IN THE DRAWINGS

REMARKS

FIG. 1A (RELATED ART)

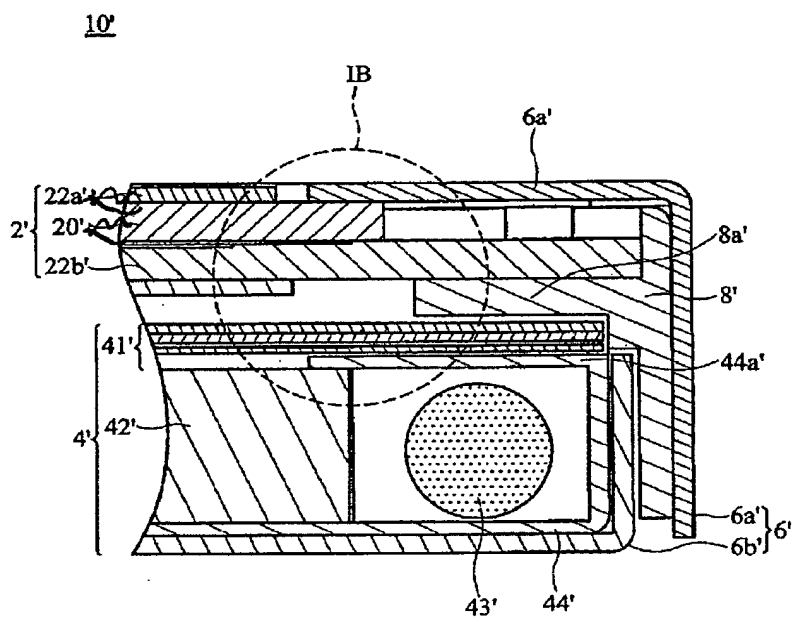
Please replace Figs. 1A, 2A, 2B, 3A and 3B with corrected drawings in the attached sheets. In these drawing sheets, minor changes have been made to lead line and reference designators, as shown in the annotated drawing sheets.
